Addendum # 01

**To the Contract Specifications and Drawings for:
Saddle Hills County
Bonanza Distribution Pumps Upgrading**

File: 5201-008-00

DESIGNED	A.M., P.P.G.	JOB	5201-008-00
DRAWN	A.M.	SCALE	1:75
DATE	JANUARY 2025	DRAWING	E2.1 ADD01

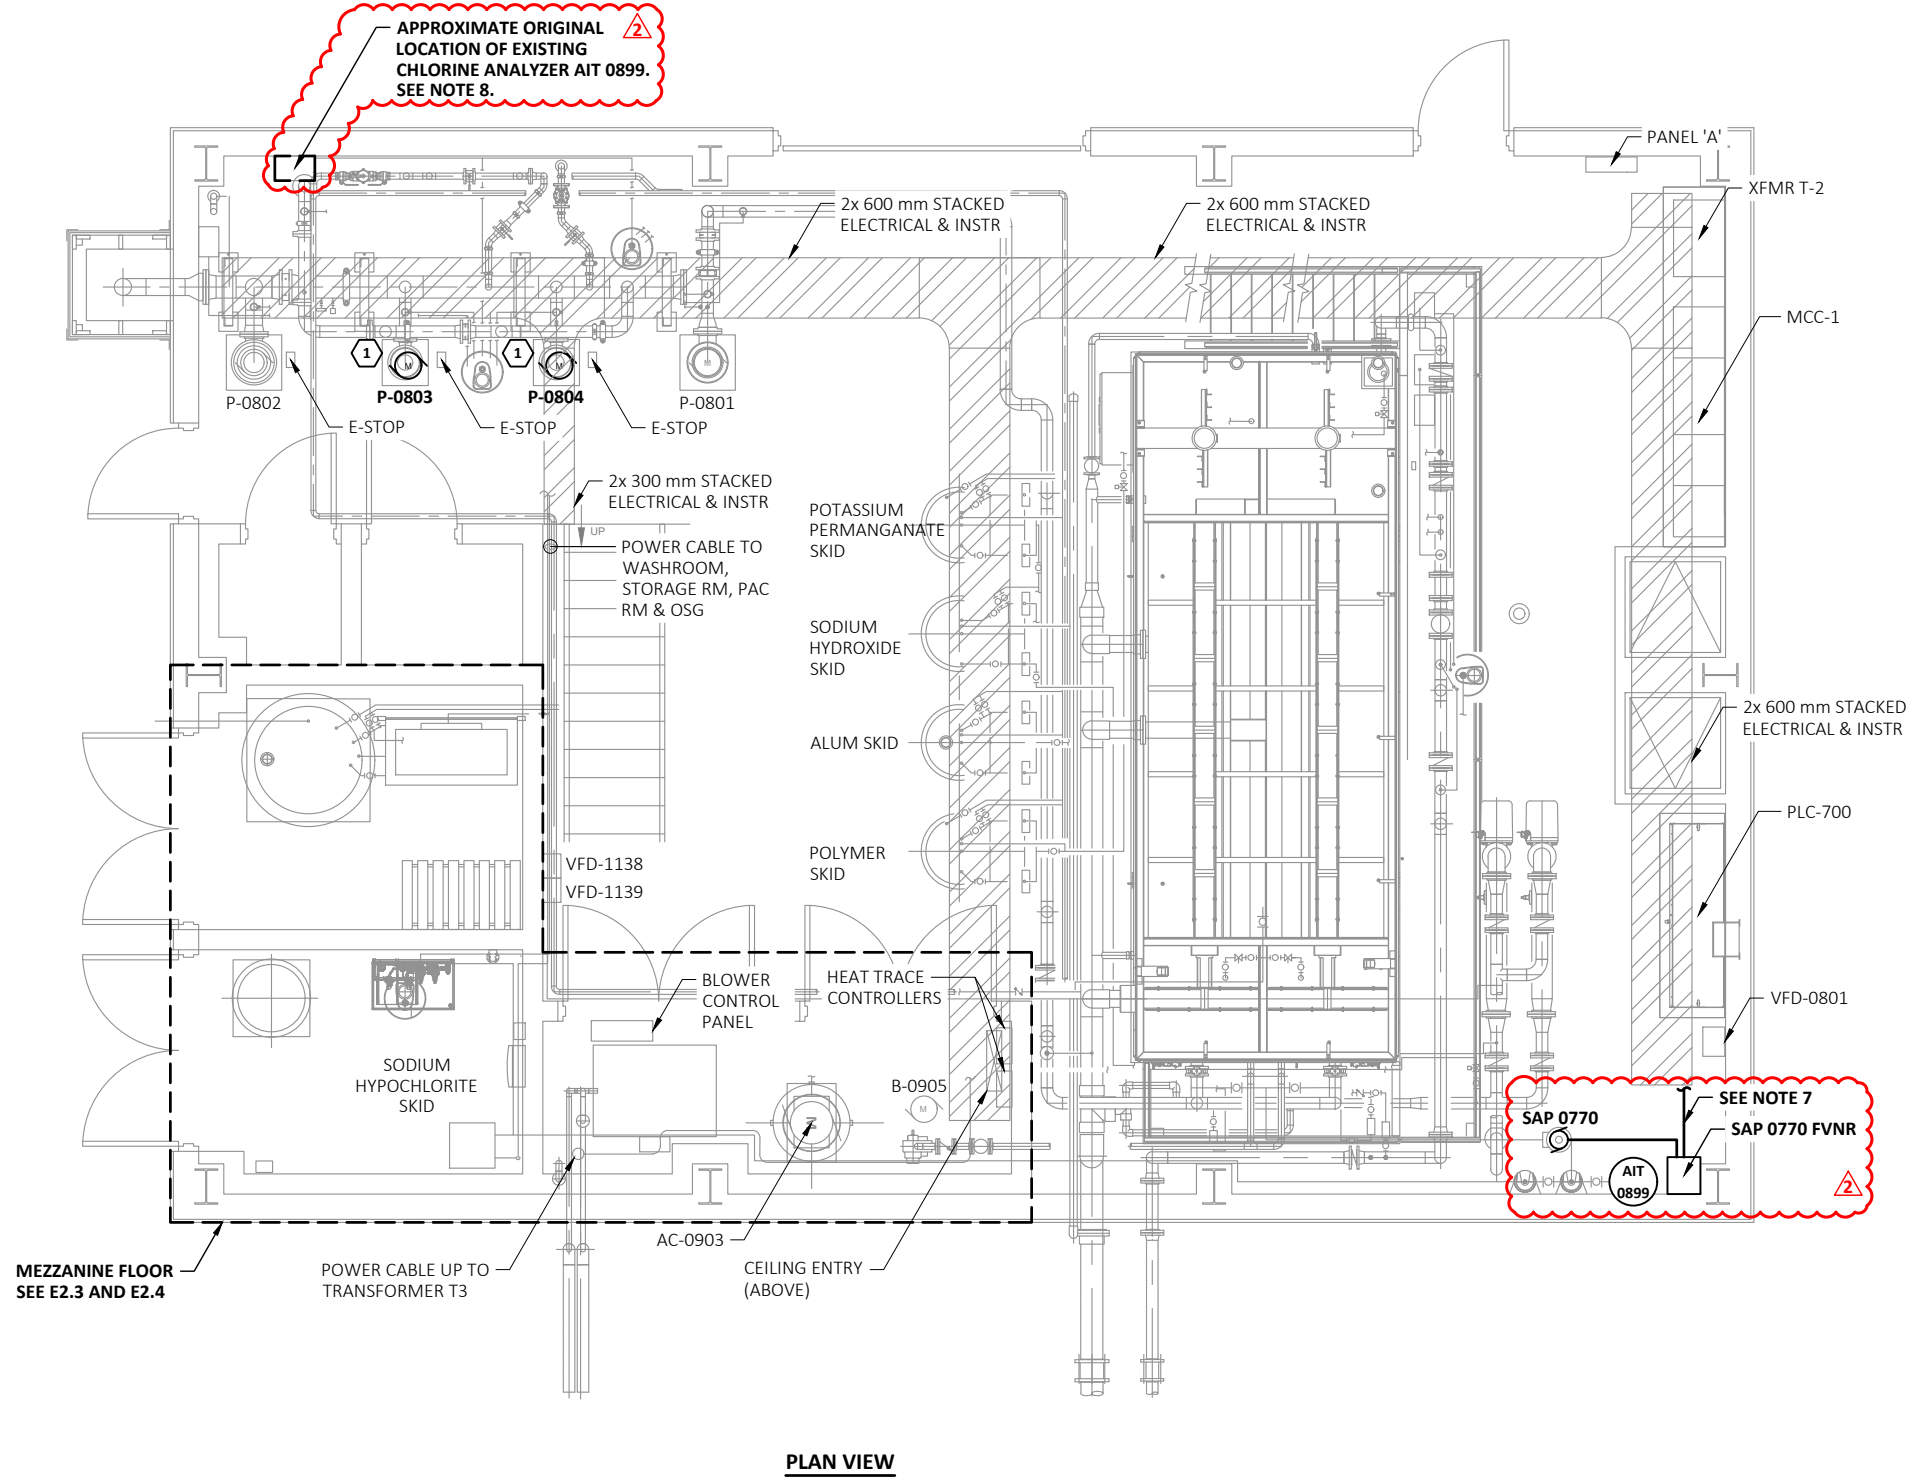
- SAP 0770 POWER FROM PANEL A AND CONTROL FROM PLC-700. TERMINATE CONTROL WIRING FOR SAP 0770 TO EXISTING SPARE I/O. SEE DRAWING E3.2 FOR WIRING DETAILS.

- RELOCATE CHLORINE ANALYZER TO NORTH EAST AREA OF THE WTP. PULL BACK POWER AND CONTROL WIRING TO NEW LOCATION.

- KEY NOTES:
- REMOVE AND REPLACE THE EXISTING MOTORS ALONG WITH THE ASSOCIATED POWER WIRING.

DESIGNED A.M., P.P.G.	JOB 5201-008-00
DRAWN A.M.	SCALE 1:75
DATE JANUARY 2025	DRAWING E2.4 ADD01

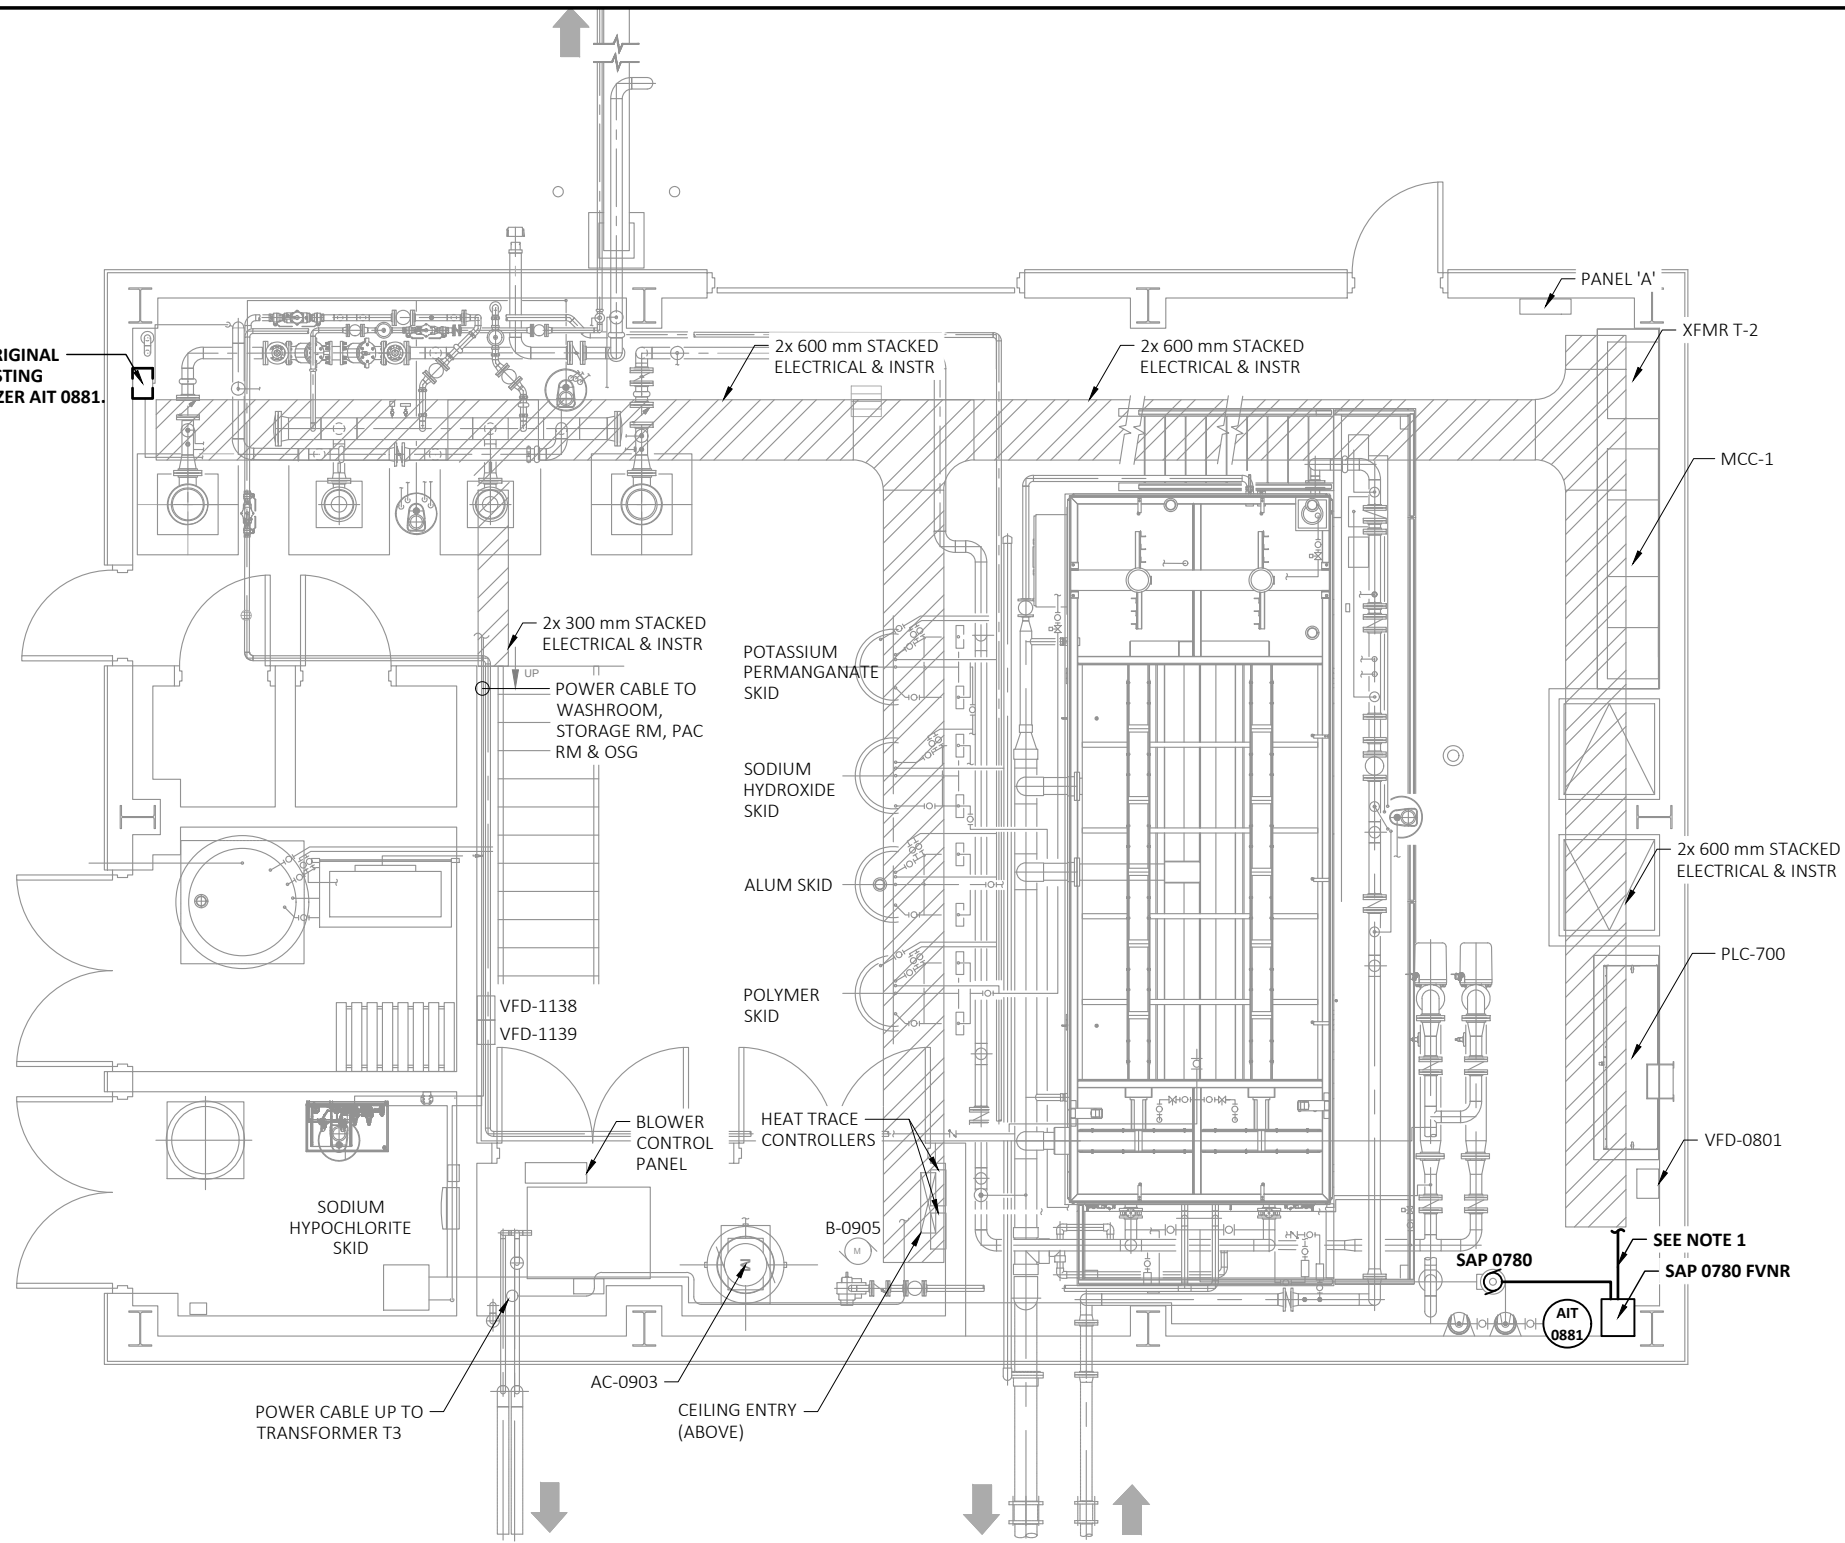
APPROXIMATE ORIGINAL LOCATION OF EXISTING CHLORINE ANALYZER AIT 0881. SEE NOTE 2.

- SAP 0780 POWER FROM PANEL A AND CONTROL FROM PLC-700. TERMINATE CONTROL WIRING FOR SAP 0780 TO EXISTING SPARE I/O. SEE DRAWING E3.2 FOR WIRING DETAILS.
- RELOCATE CHLORINE ANALYZER TO NORTH EAST AREA OF THE WTP. PULL BACK POWER AND CONTROL WIRING TO NEW LOCATION.
